Meeting with NRC to discuss RSIs for HI-STAR PBT 02/10/22

Overview

Table 1: Benchmark Comparison for 1-Inch Cube Specimen	
Result	Percentage Difference between Physical Test Measurement and Numerical Prediction
Impact Duration	1.6%
Maximum Foam Deformation	-0.4%

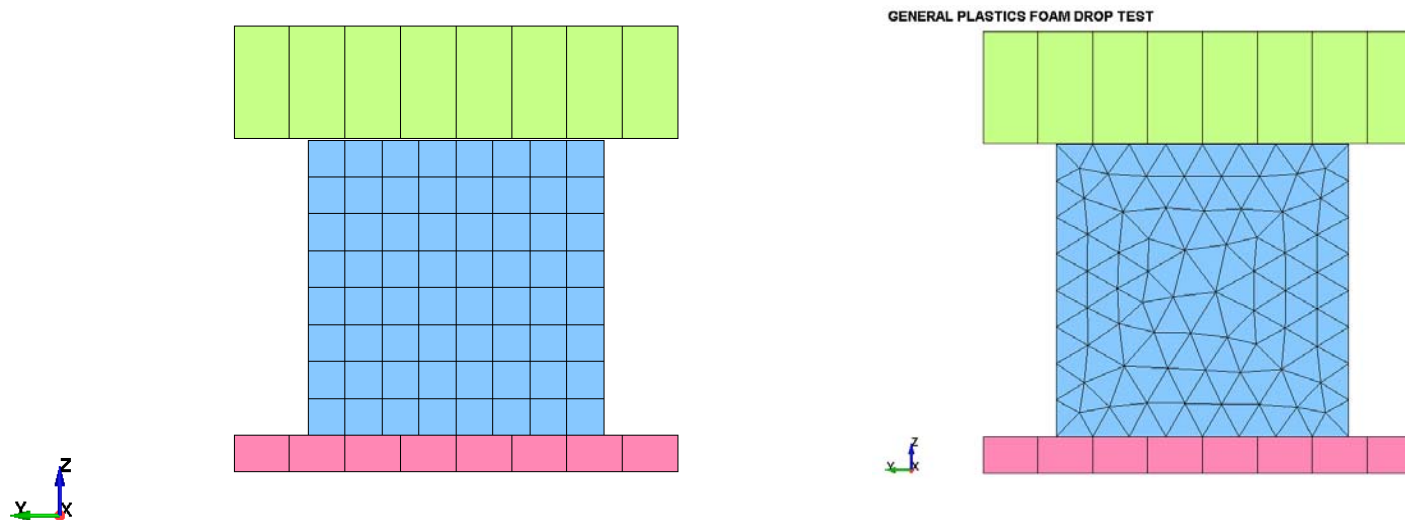
- Benchmark analysis for polyurethane foam is documented in Holtec Report No. HI-2210574 (submitted with HI-STAR PBT application)
- Benchmarking is based on three (3) independent sets of physical test measurements for a range of geometries and constructions
 - Component level (1" cube specimen)
 - Assembly level (HI-STAR 63 & NuPac 125-B)
 - Confined and unconfined test specimens
- All physical tests used for benchmarking utilize the same polyurethane foam material as the one proposed for HI-STAR PBT
- Benchmark work culminated in a universal foam material model with a singular strain rate curve that shows excellent agreement (within 7%) with all 3 sets of physical tests

- Enhance existing benchmark report (HI-2210574) and HI-STAR PBT SAR to further describe and justify benchmarking of polyurethane foam material
- Perform additional testing of polyurethane foam material, as necessary, to supplement current benchmark work
 - ❑ Component level vs. assembly level testing
 - ❑ Static vs. dynamic testing

**Table 2: Benchmark Comparison for HI-STAR 63 Scale Model
(9-Meter Top End Drop)**

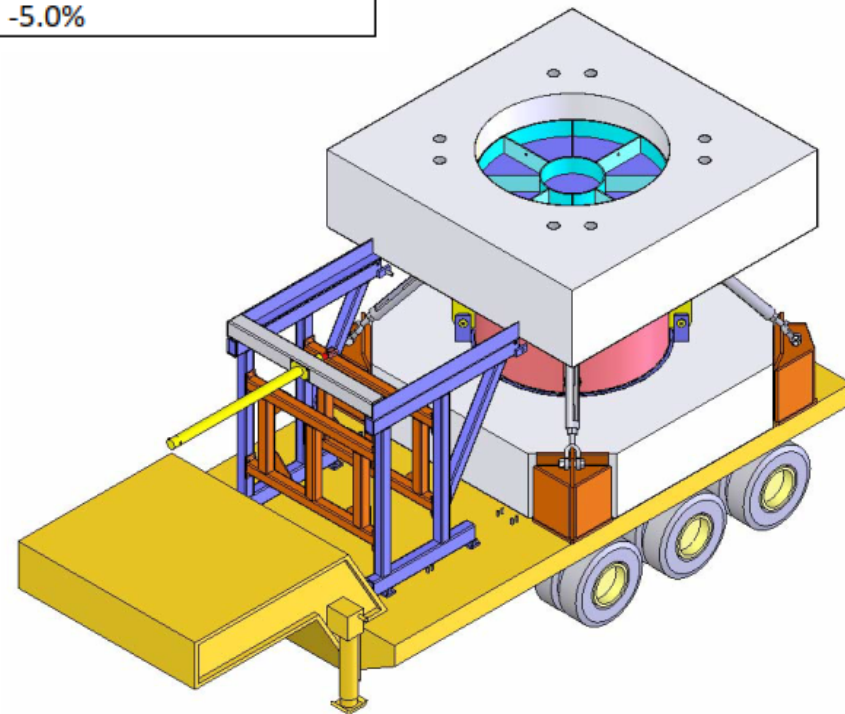
Result	Percentage Difference between Physical Test Measurement and Numerical Prediction
Peak Cask Deceleration	3.2%
Impact Limiter Deformation	-6.7%
Impact Duration	-5.0%

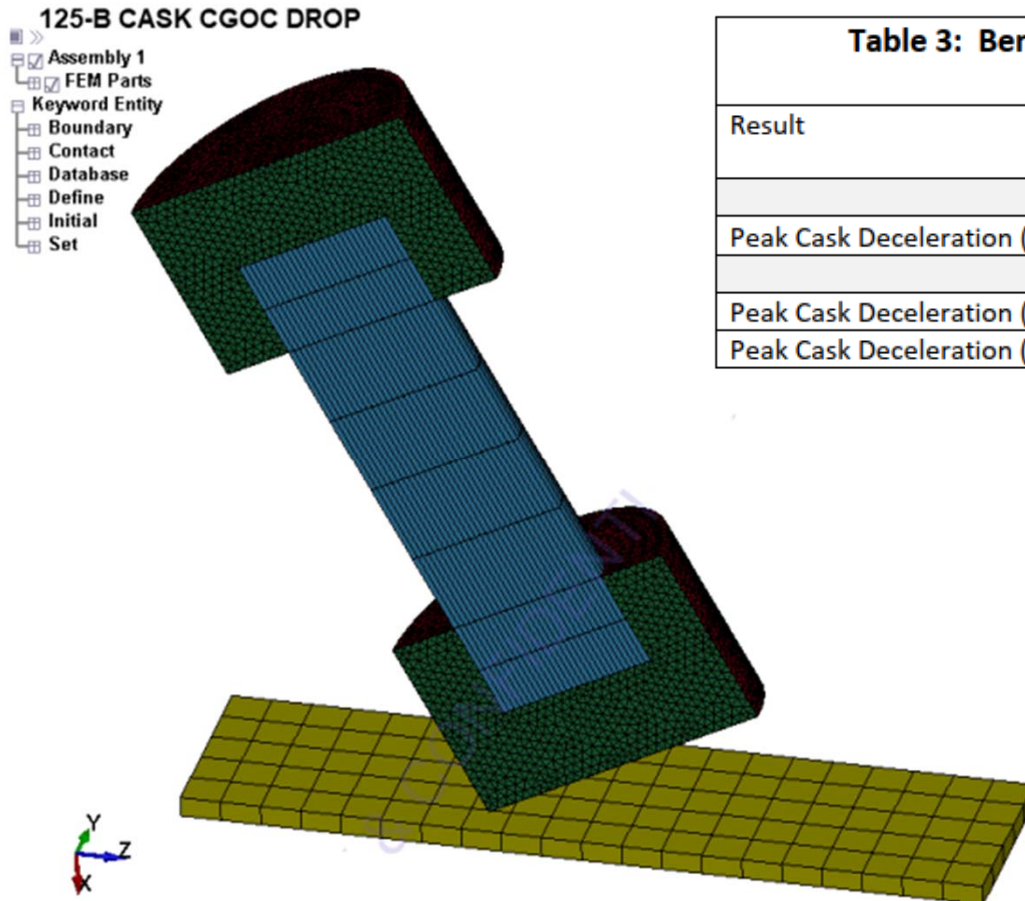
Table 3: Benchmark Comparison for NuPac 125-B Scale Model (9-Meter Side & CGOC Drops)	
Result	Percentage Difference between Physical Test Measurement and Numerical Prediction
Side Drop	
Peak Cask Deceleration (X-Dir)	-5.7%
CGOC Drop	
Peak Cask Deceleration (X-Dir)	2.8%
Peak Cask Deceleration (Z-Dir)	-6.3%

Proposed Resolution Path for RSI-2

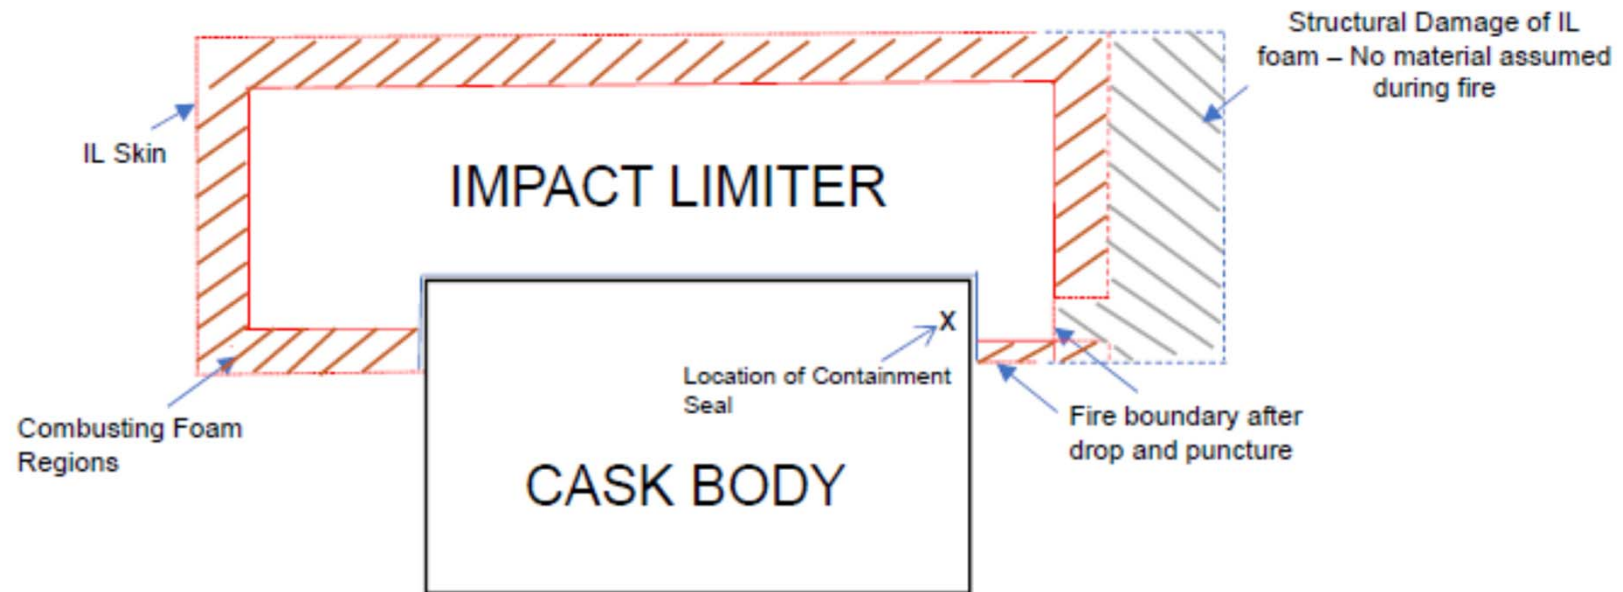
- LS-DYNA drop simulations for HI-STAR PBT show no breach of IL skin, but weld seams are not explicitly modeled
- Drop testing of other packages with similar stainless steel enclosure (HI-STAR 100, NuPac 125-B) indicate that weld seams may fail at the point of impact where the impact limiter is permanently deformed
- SAR Chapter 3 contains thermal analysis of HI-STAR PBT package under HAC fire event which conservatively assumes a severe puncture of impact limiter enclosure and places fire flame boundary in close proximity to the cask (subject of RSI-3)

- Improve geometry of weld seams for impact limiter skin to provide more metal overlap and mitigate the direct exposure of foam to HAC fire event following a 9-meter drop
- Perform additional LS-DYNA simulation for 1-meter puncture where the puncture bar strikes the top impact limiter at the same location postulated in SAR Chapter 3 for the thermal analysis of the HAC fire event
 - Show that the predicted damage to the top impact limiter is less than what is conservatively assumed in SAR Chapter 3
